ADDENDUM NO. 1

Bid Package 13-01R

BROOKSIDE ELEMENTARY SCHOOL – BUILDING B (200)
DSA NO. 03-113415

OAK PARK UNIFIED SCHOOL DISTRICT

AD1-1

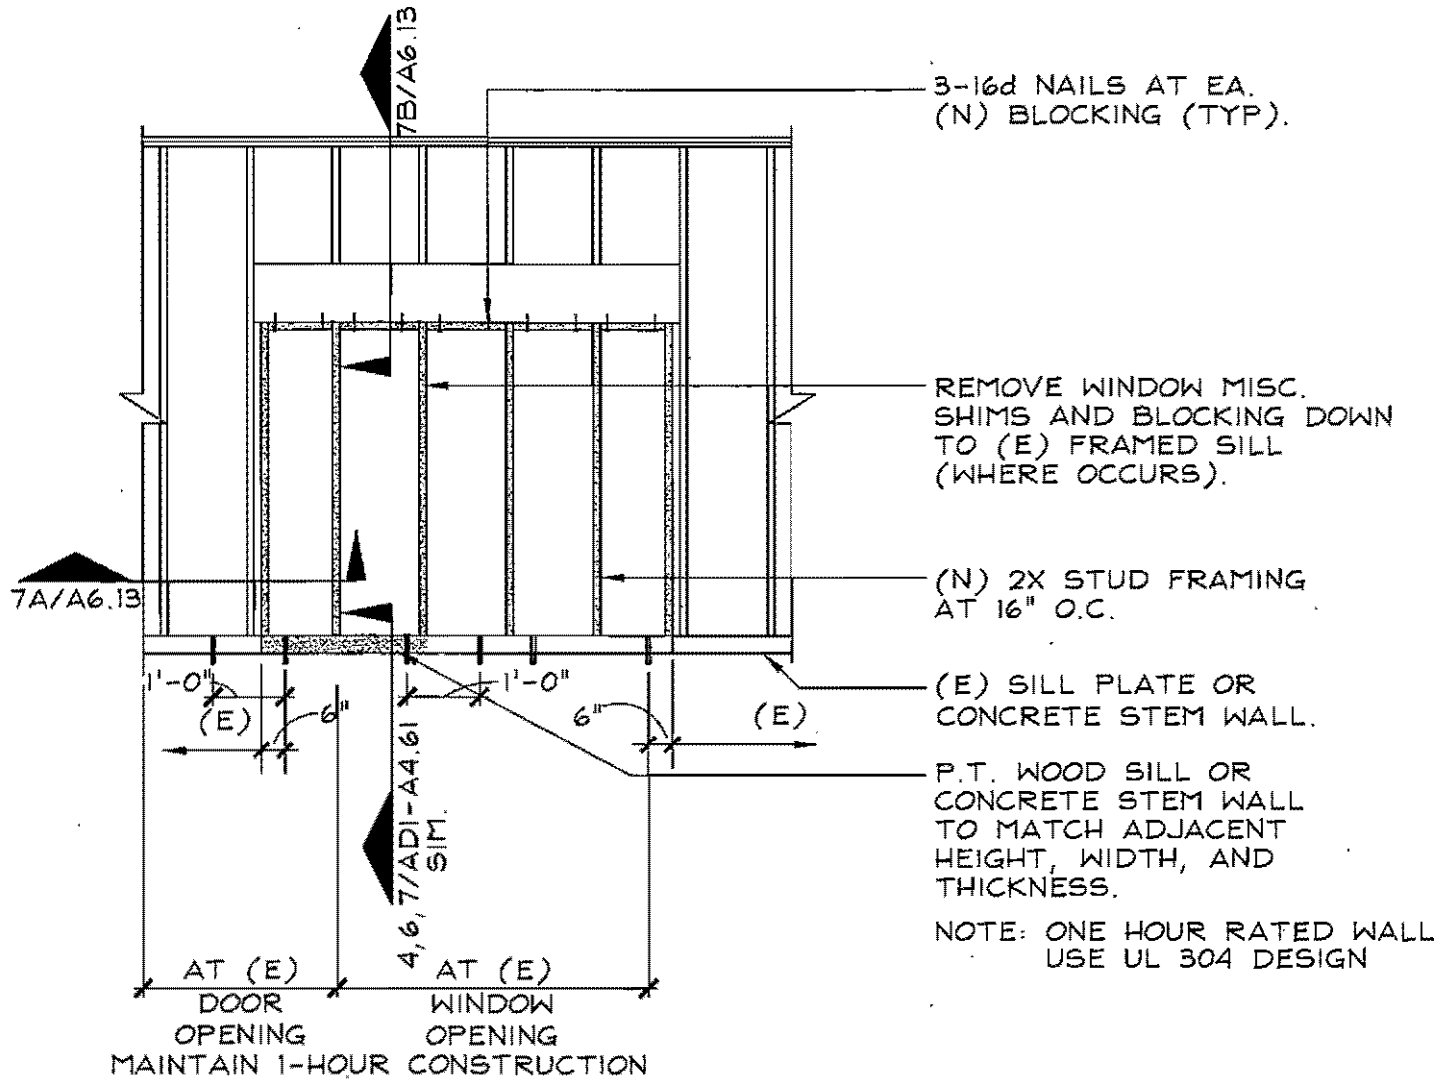
Refer to DSA-approved Drawing A6.13, dated September 2, 2009, delete Detail 6 and replace with the attached Drawing AD1-1, dated January 7, 2013.

6 INFILL FRAMING AT EXISTING OPENING

AD1-2

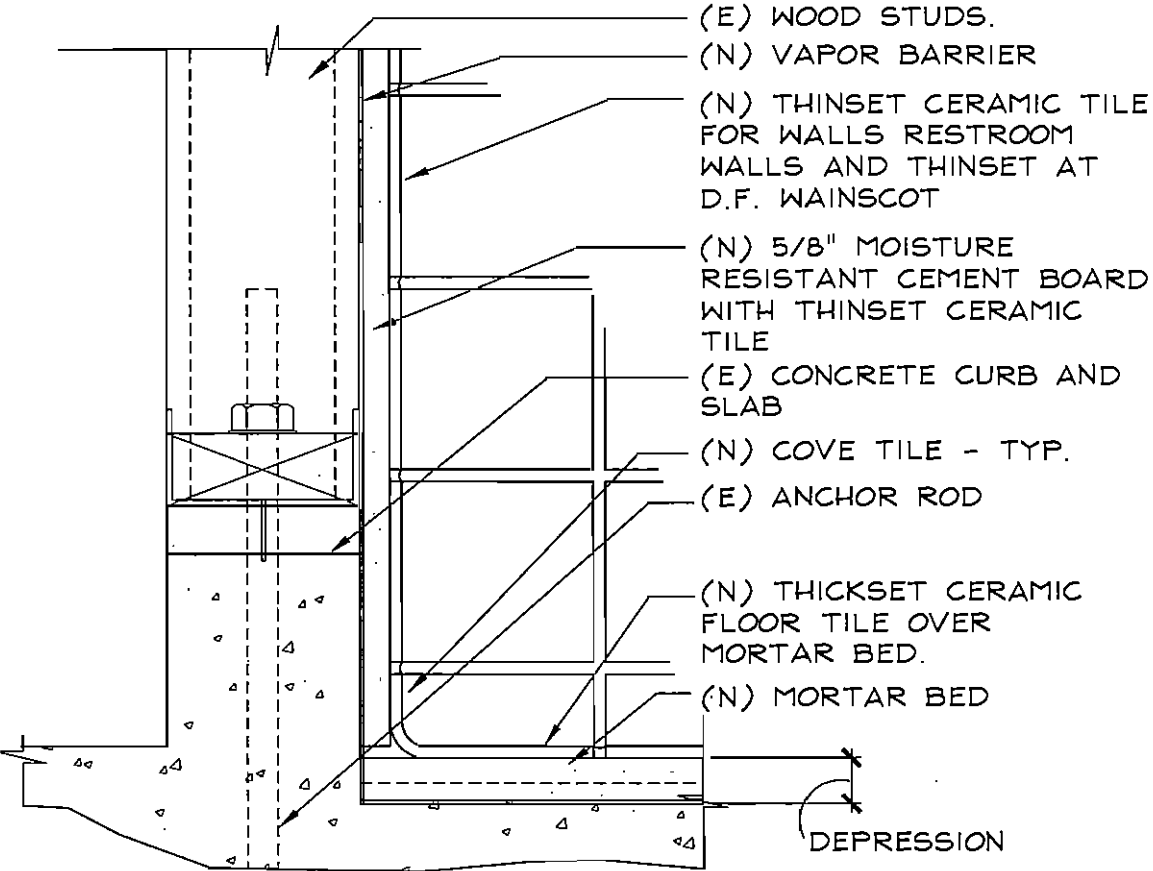
Refer to DSA-approved Drawing A6.13, dated September 2, 2009, delete Detail 13 and replace with the attached Drawing AD1-2, dated January 7, 2013.

13 COVED CERAMIC TILE BASE

AD1-3

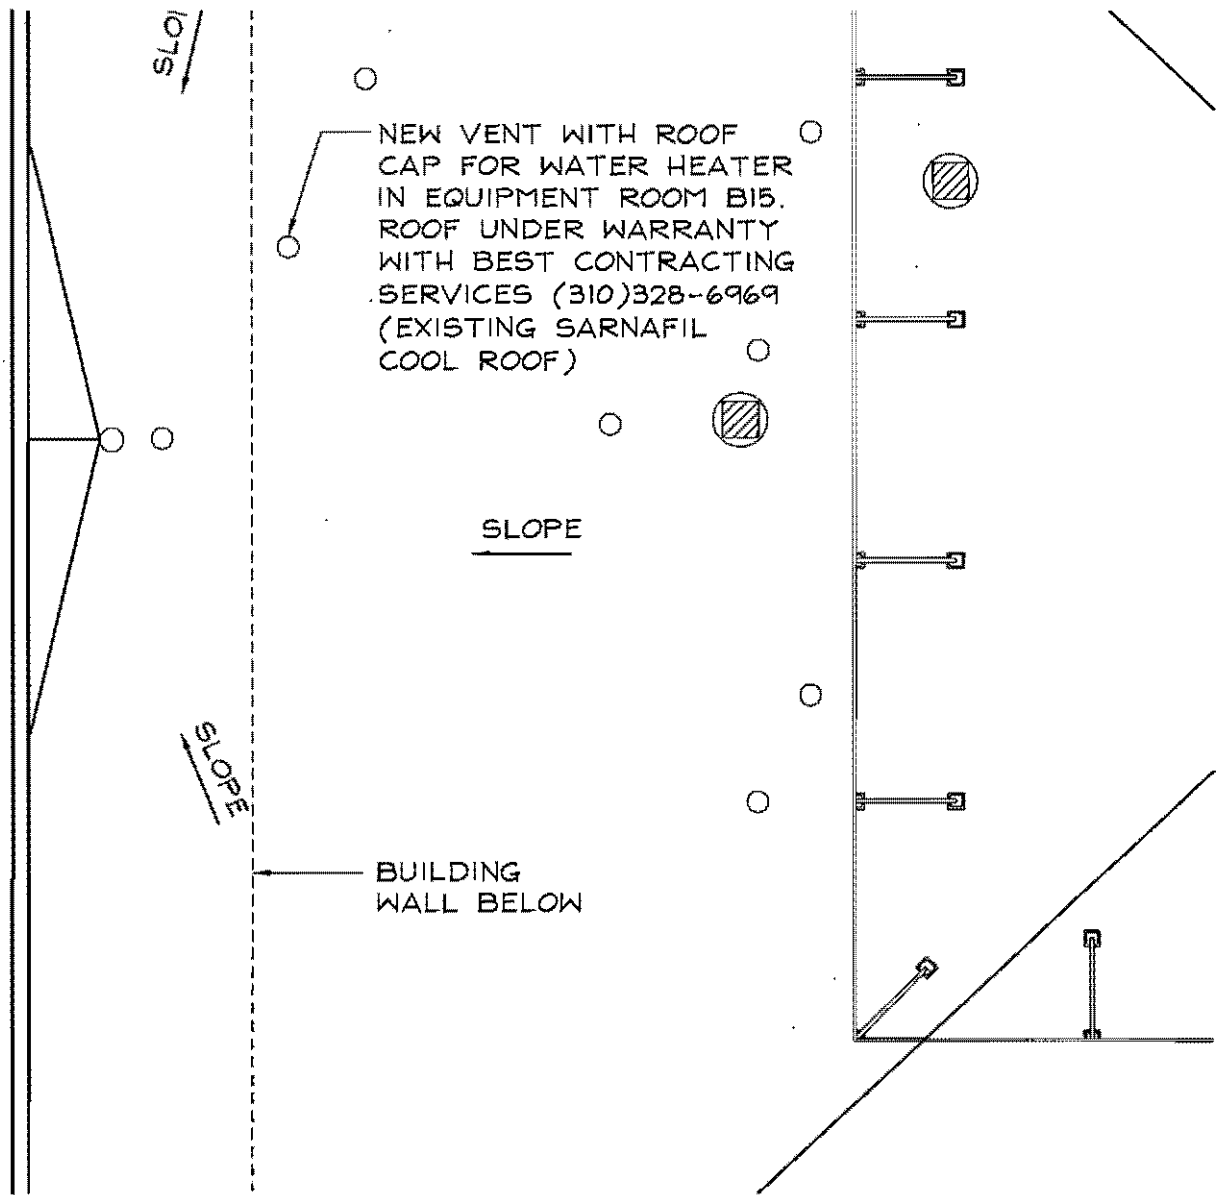
Add the attached Drawing AD1-3, dated January 7, 2013.

PARTIAL ROOF PLAN

AD1-4

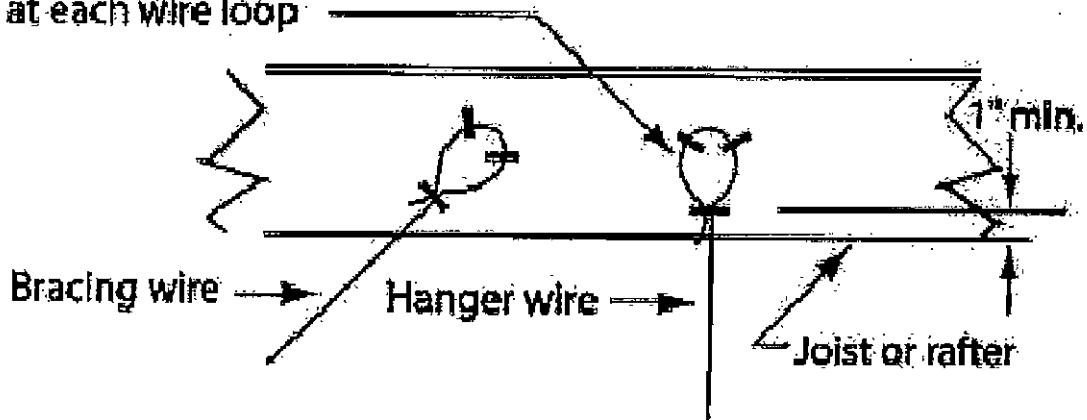
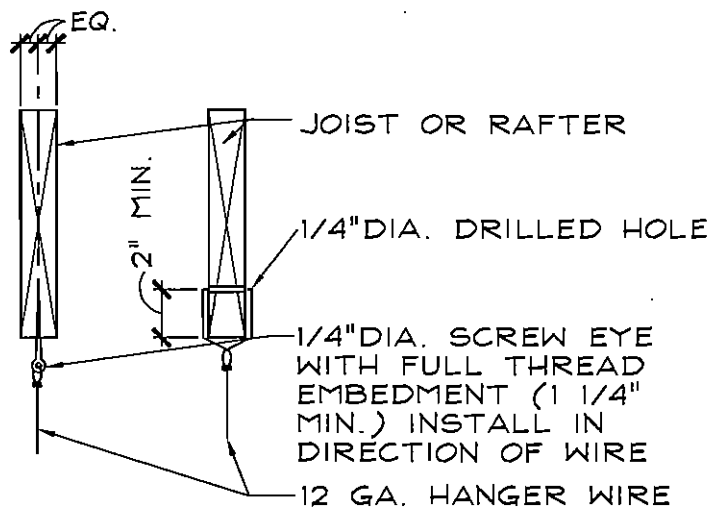
Refer to DSA-approved Drawing A7.60, dated September 2, 2009, delete Details 9B and 9E and replace with the attached Drawing AD1-4, dated January 7, 2013.

9 SUSPENSION WIRE CONNECTION TO OVERHEAD STRUCTURE

AD1-5

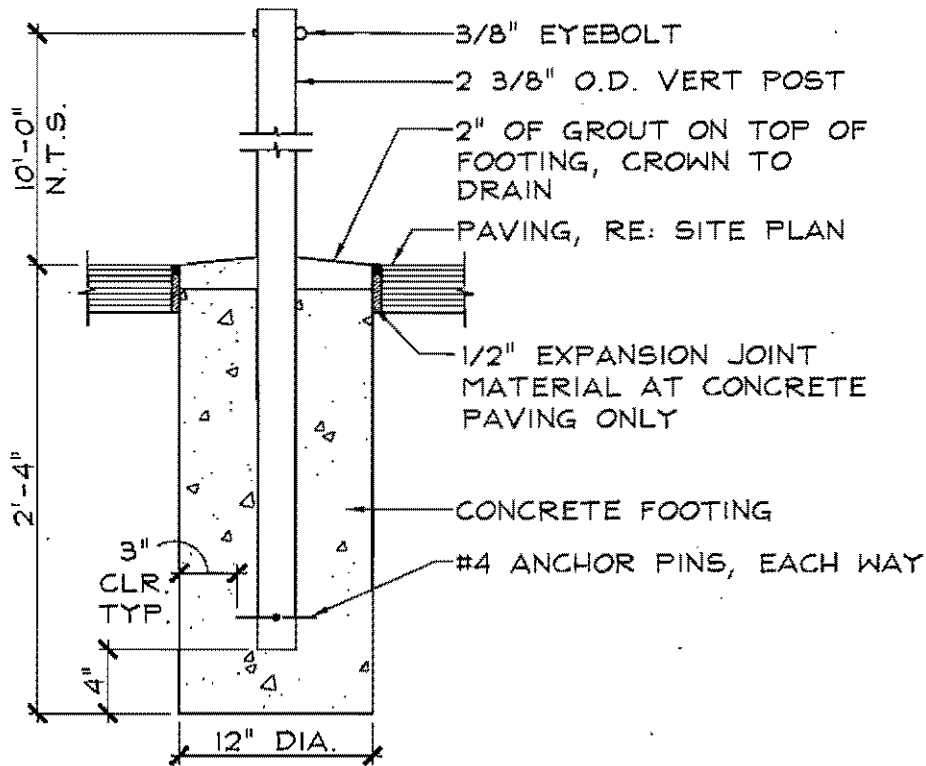
Refer to DSA-approved Drawing A1.1, dated September 2, 2009 and add the attached Drawing AD1-5, dated January 7, 2013.

REMOVE (1) DAMAGED TETHER BALL
POLE NEAR SOUTHEAST CORNER OF
BUILDING B AND INSTALL NEW PER
THIS DETAIL

AD1-6

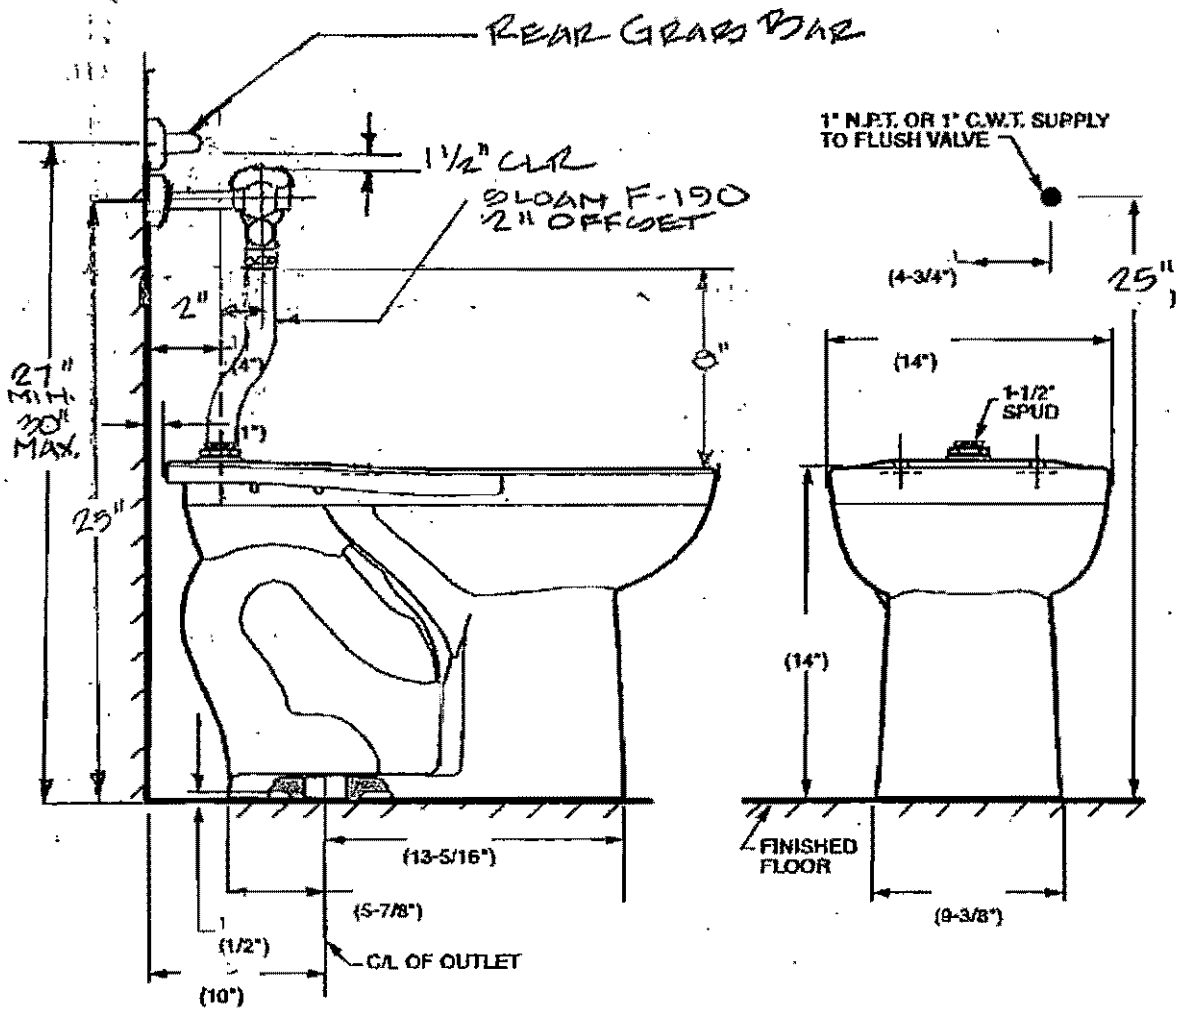
Add the attached Drawings AD1-6 and AD1-7, dated January 7, 2013.

FLUSH VALVE DETAIL
